ADDENDUM NO. CC-1

TELEGRAPH DISTRICT
401 BUILDING RENOVATION
LINCOLN, NEBRASKA
DLR GROUP PROJECT NO. 10-16202-00

February 26, 2016

E2.0
10-16202-00
02/26/2016
Revised
Addendum 1 03/11/16

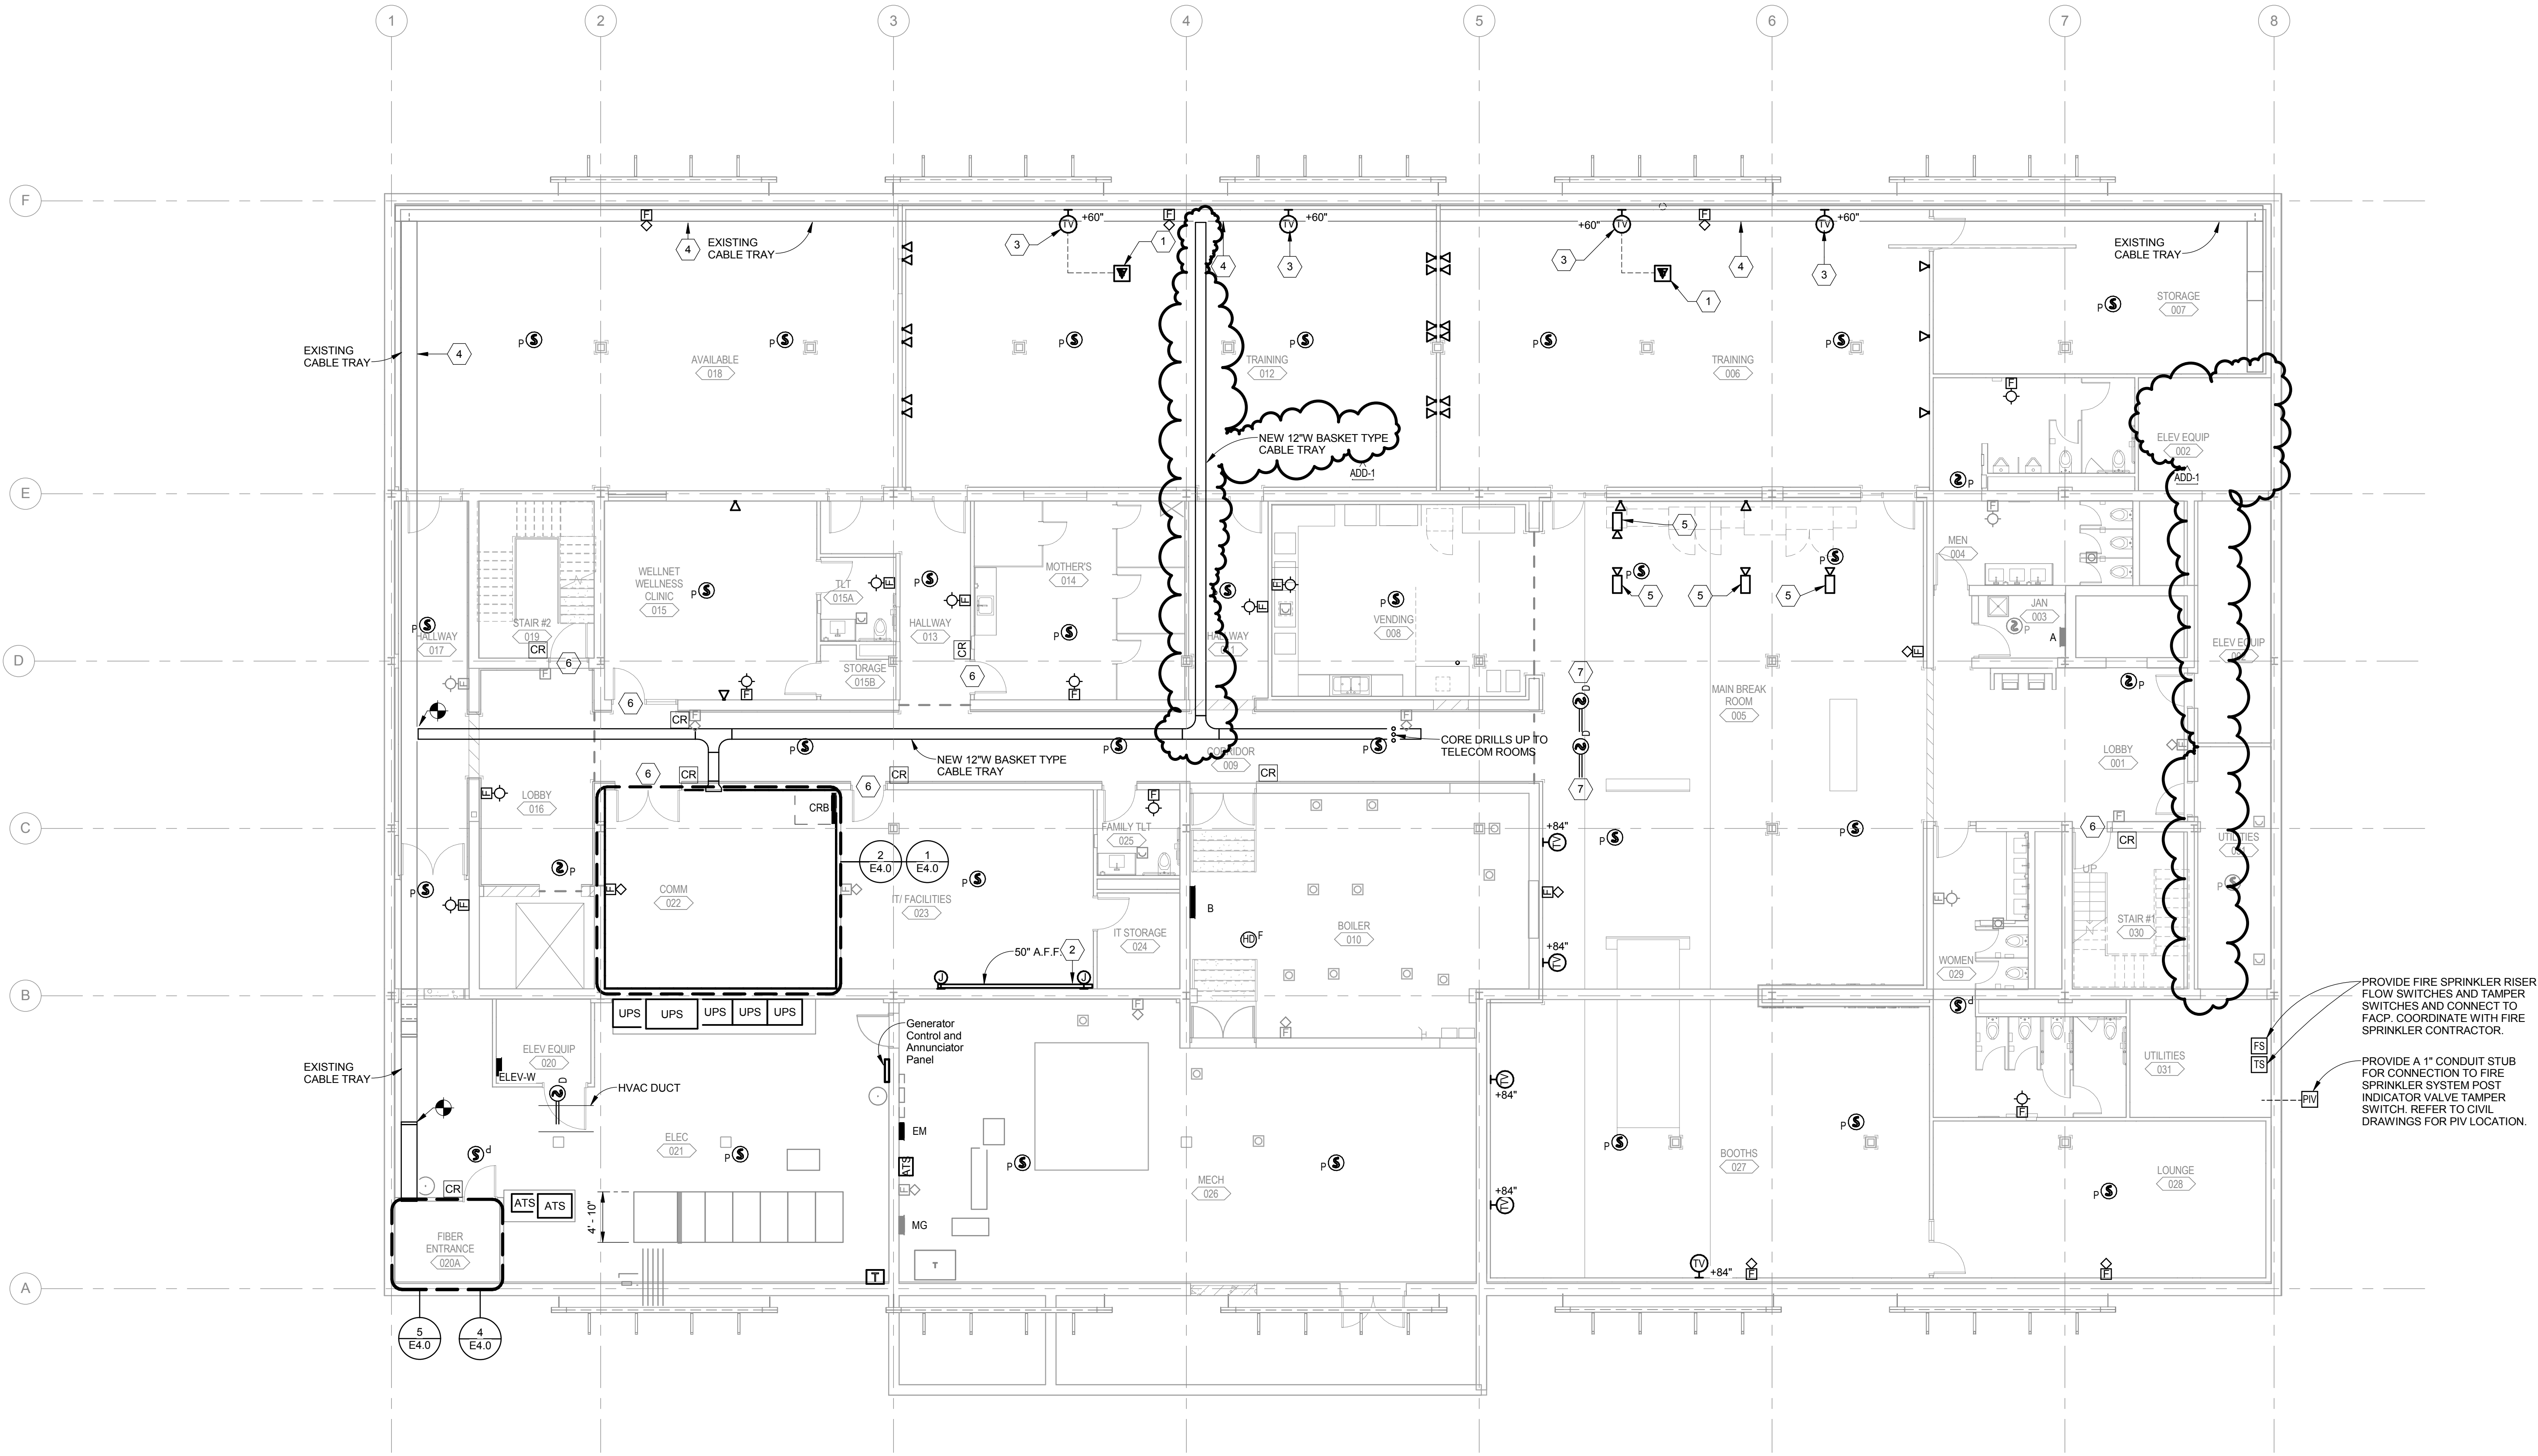
ITEM NO. 36 Drawing E2.0 SYSTEMS PLAN, BASEMENT LEVEL

- A. Revise the drawing to add a section of wire basket cable tray as shown in the attached drawing E2.0.
B. Revise the drawing to remove a section of the existing cable tray that passes through ELEV EQUIP 002 as shown in the attached drawing E2.0.

E2.1

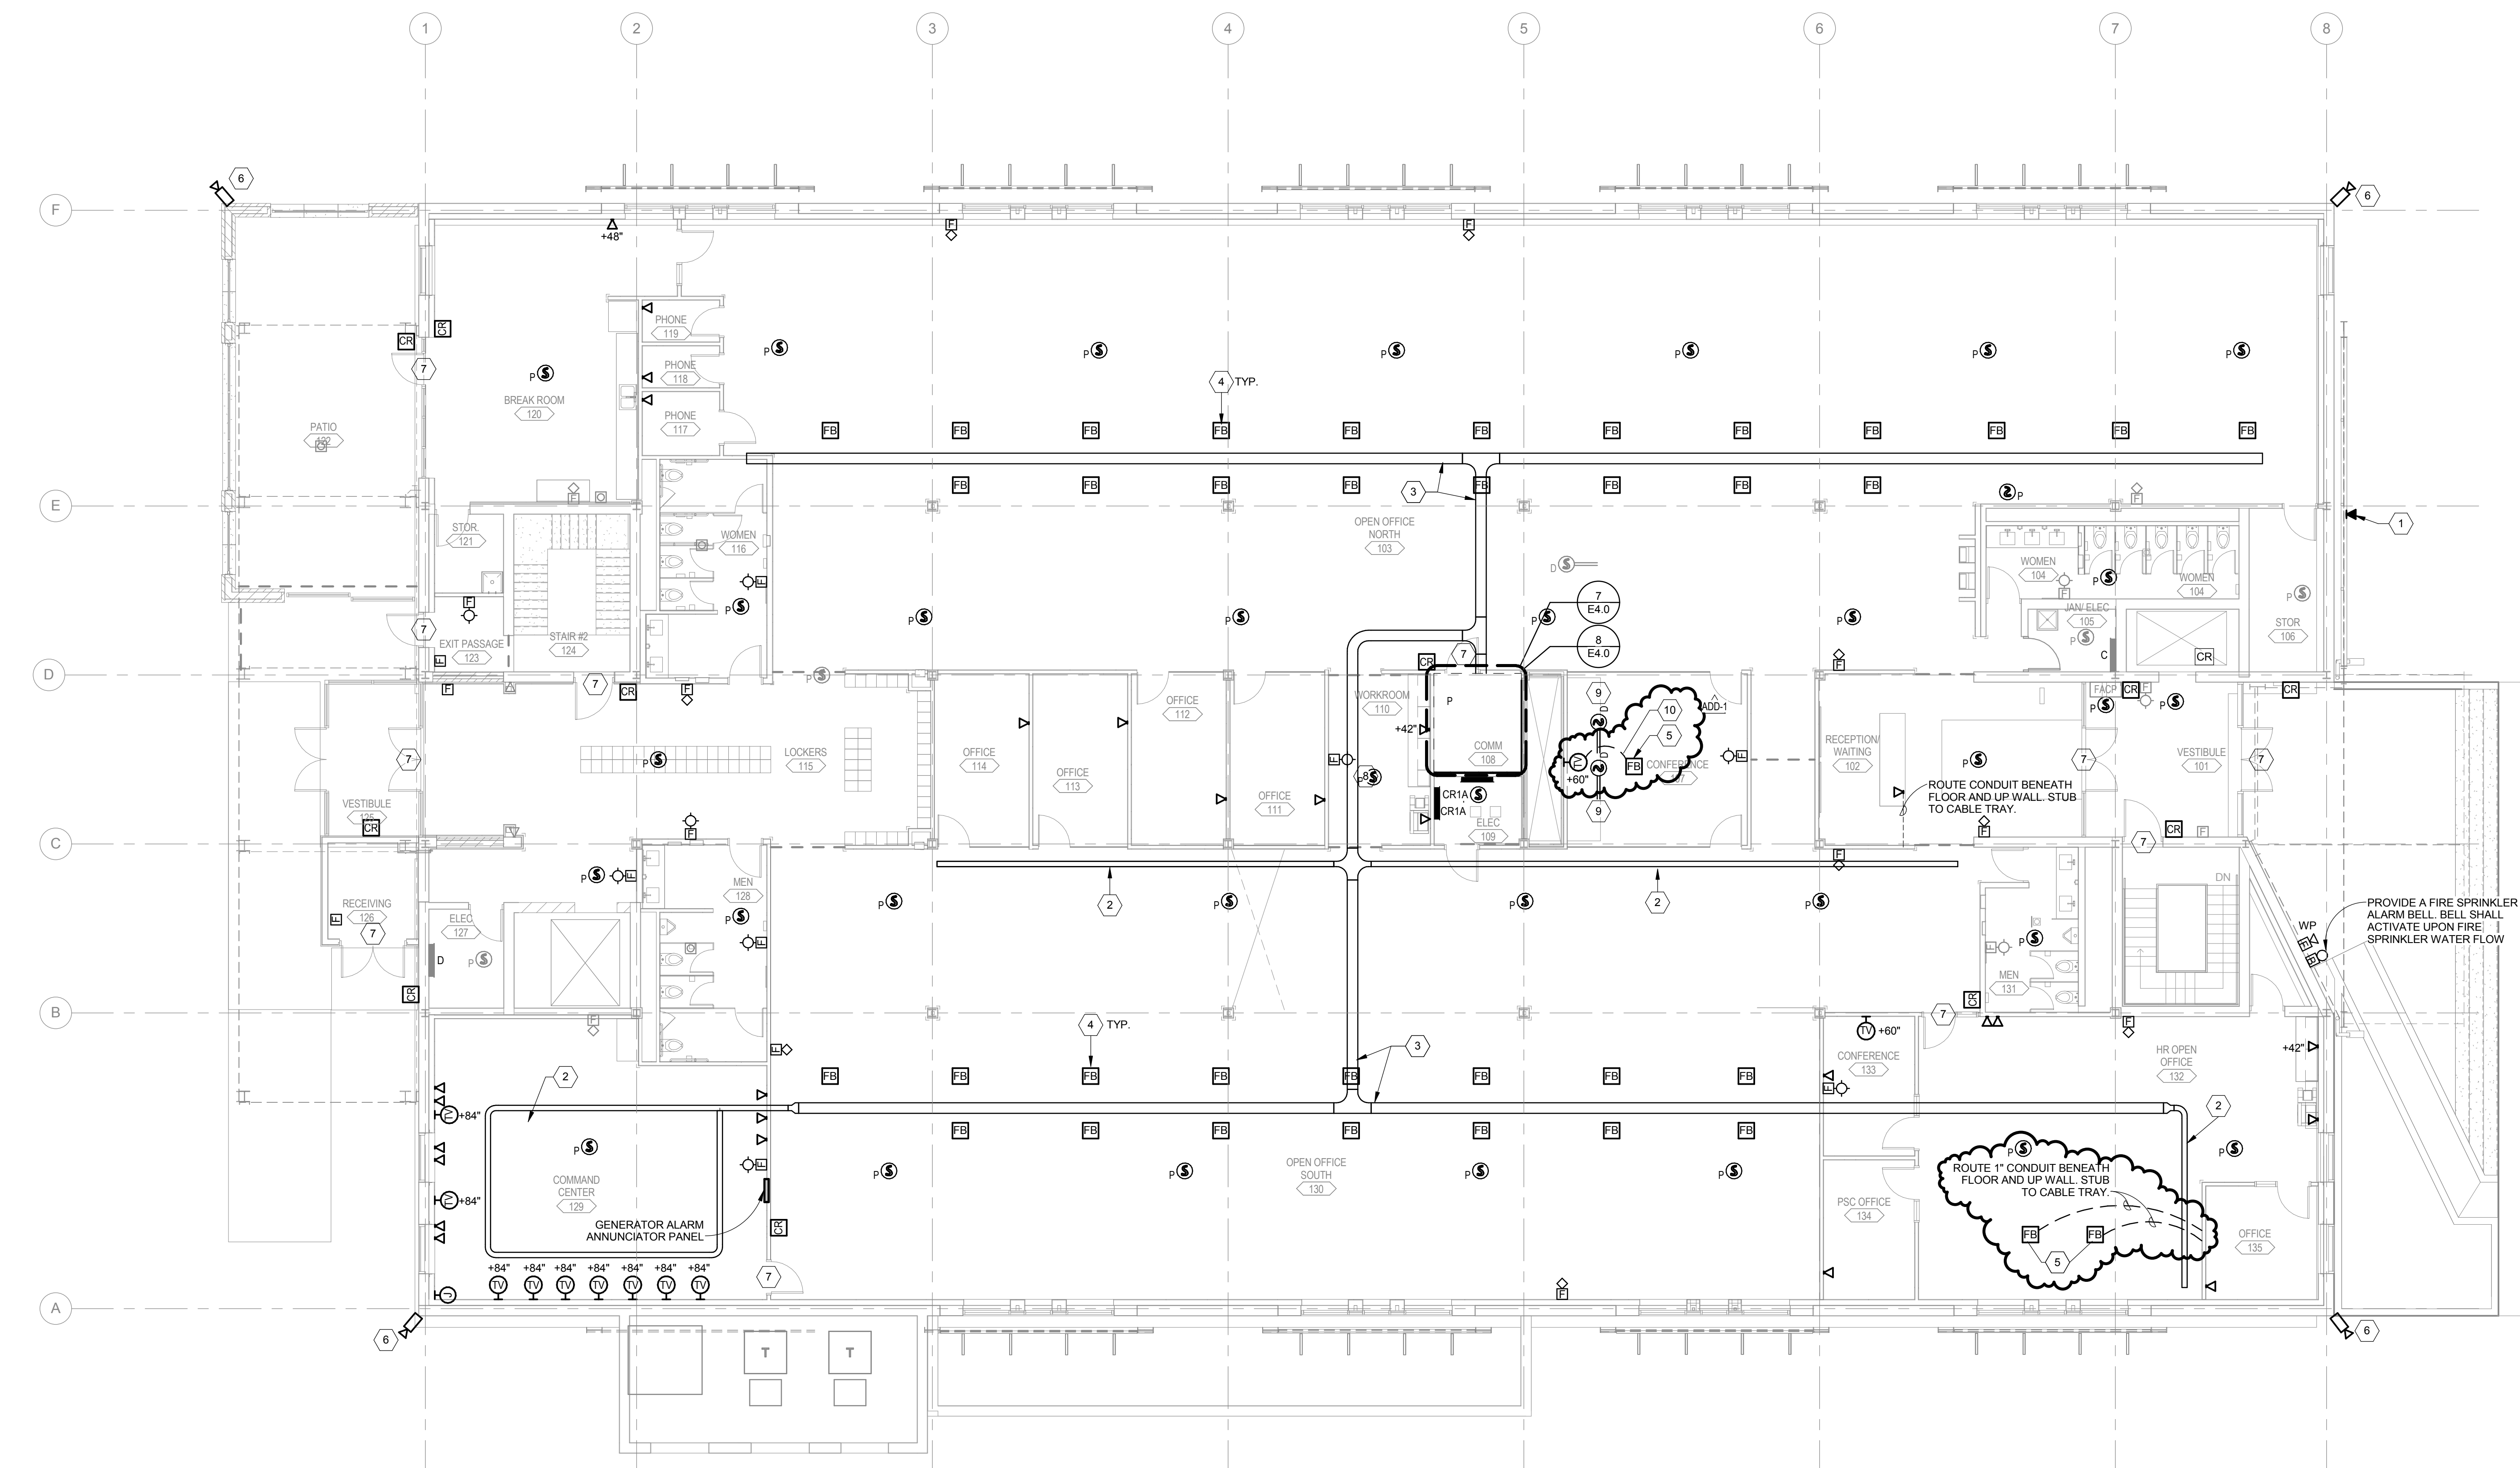
ITEM NO. 37 Drawing E2.1 SYSTEMS PLAN, FIRST LEVEL

- A. Add Keynote 10 and conduit from the floor box to the TV location in each conference room as shown in the attached drawing E2.1.
B. Add conduit from the floor boxes in HR OPEN OFFICE stubbed to the Cable Tray located above the ceiling as shown in the attached drawing E2.1.

1 ENLARGED WEST ELEVATOR PLAN
E4.1 SCALE: 1/4" = 1'-0"

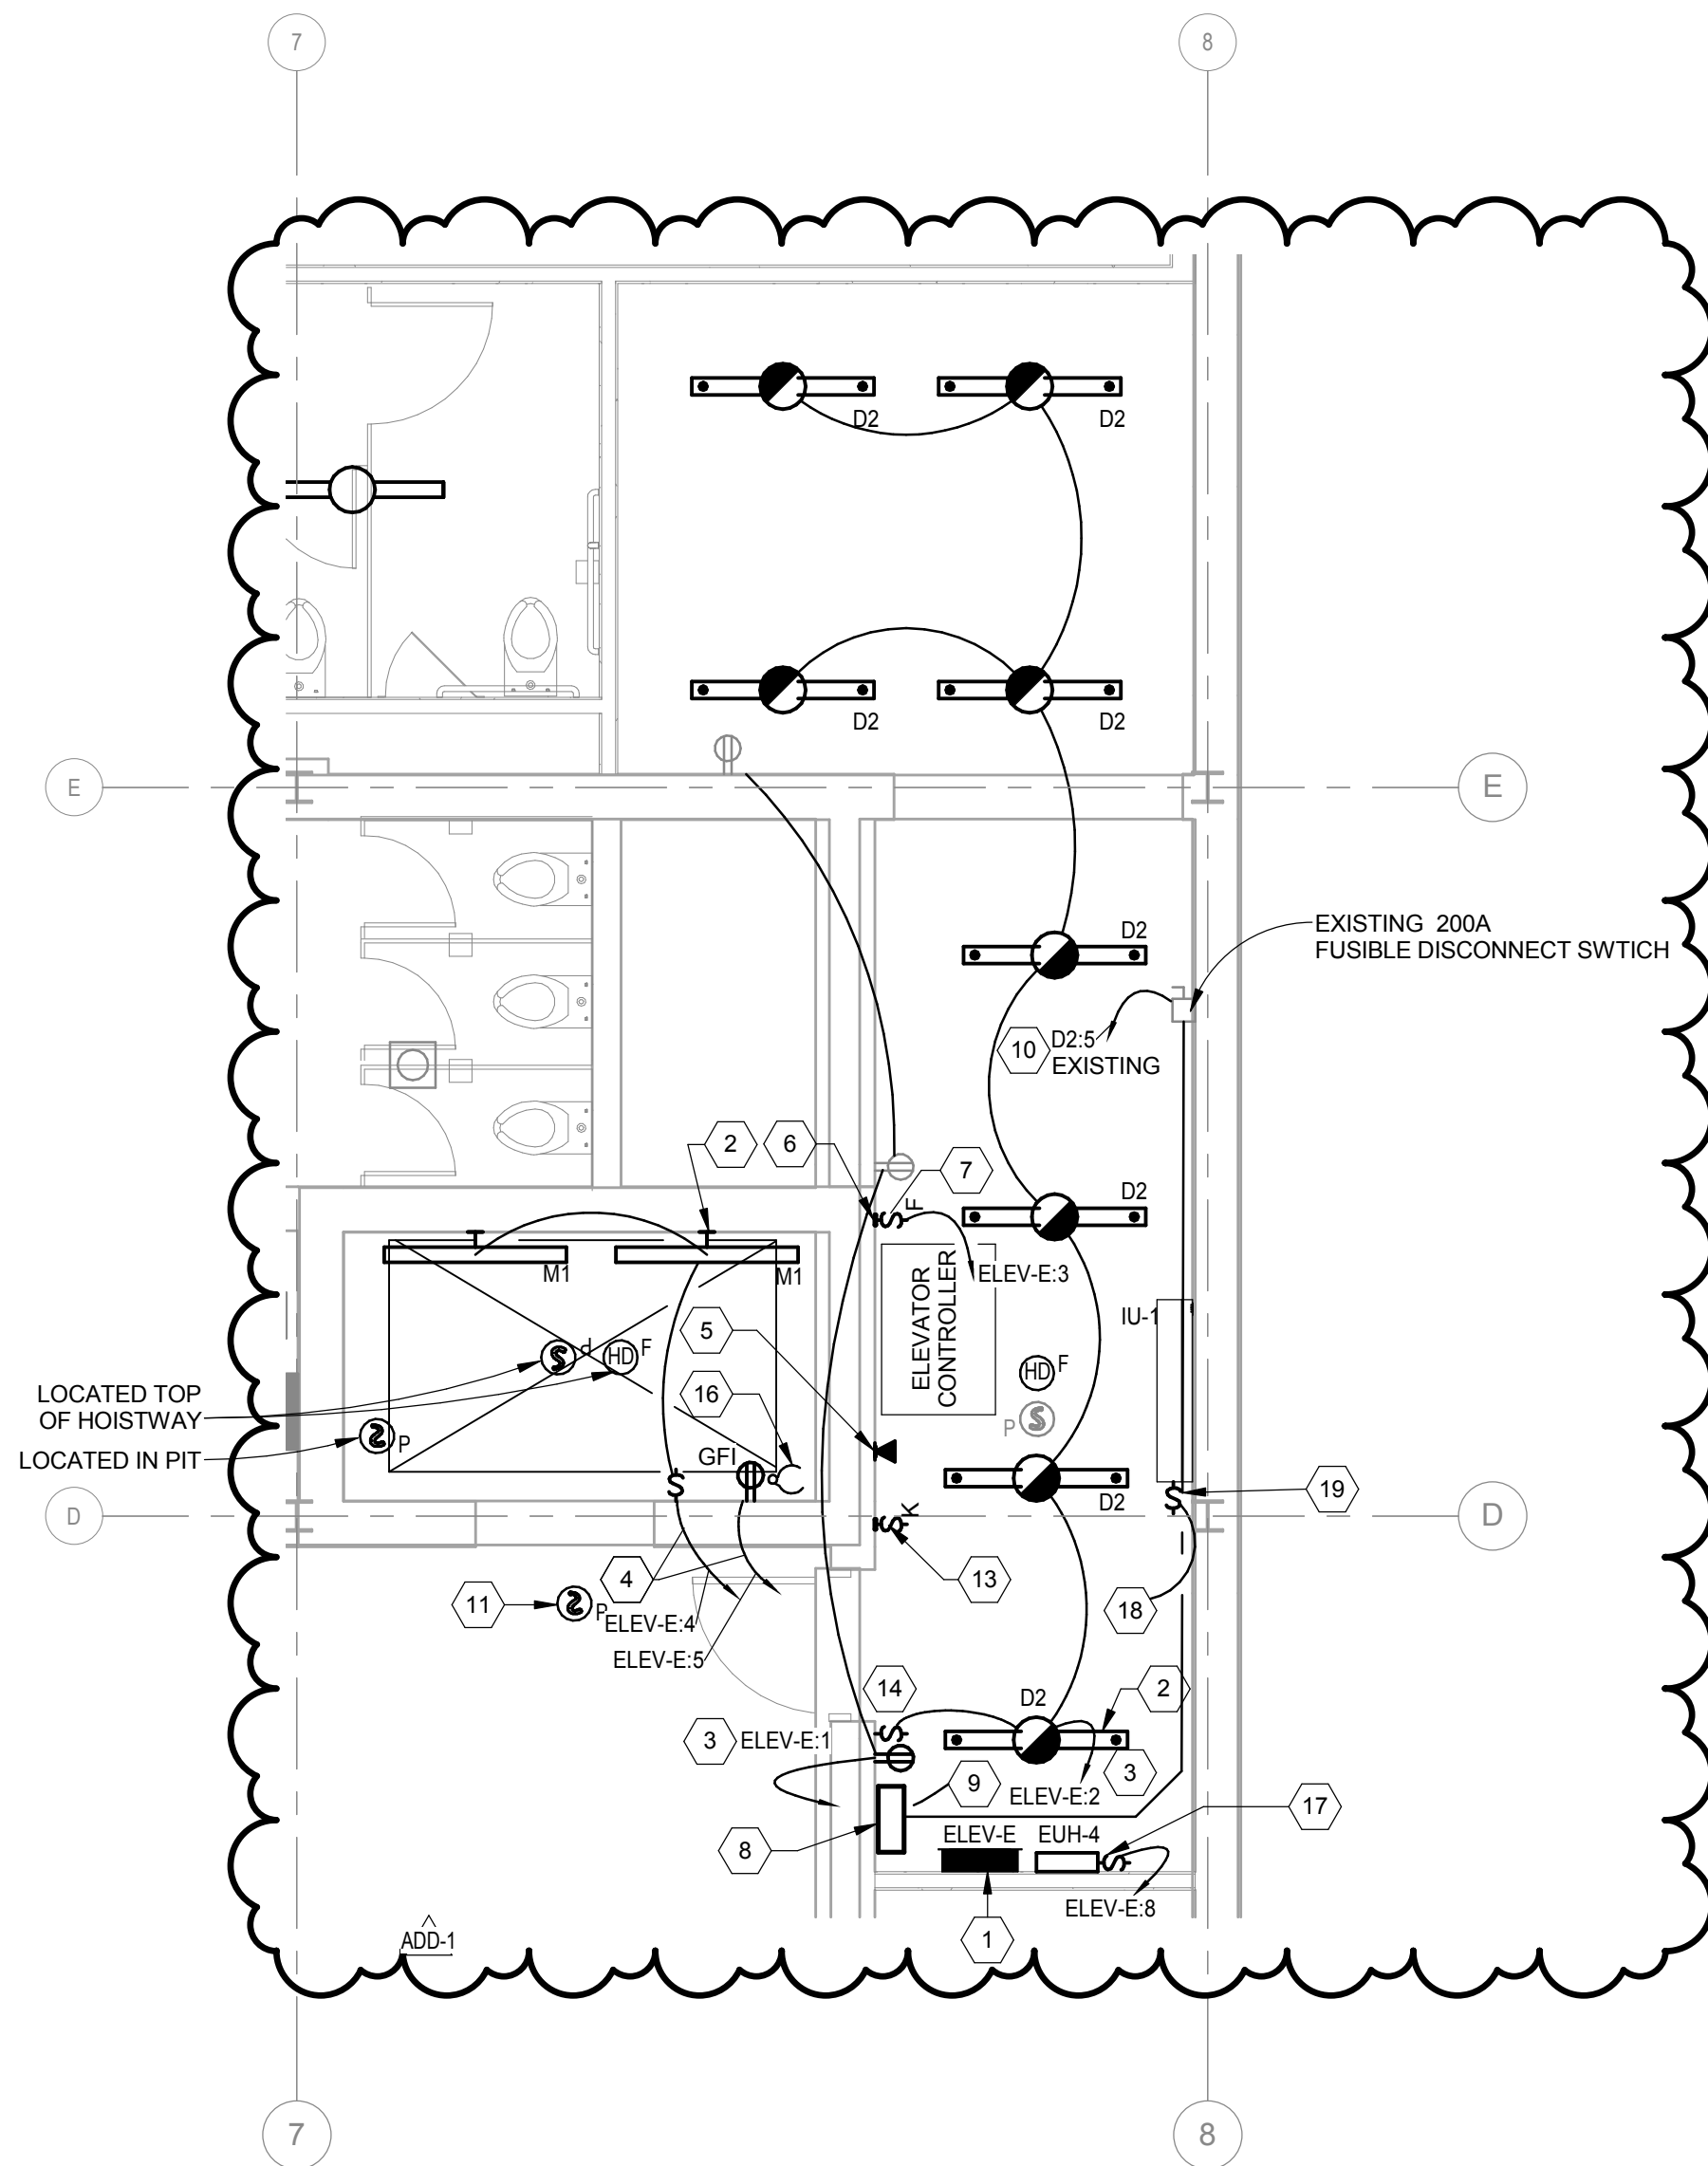
- A. Revise Detail 1 for the West Elevator Plan as shown in attached drawing E4.1.
B. Revise Detail 2 for the East Elevator Plan as shown in attached drawing E4.1
C. Revise Detail 4 for the Enlarged Penthouse Plan as shown in attached drawing E4.1.
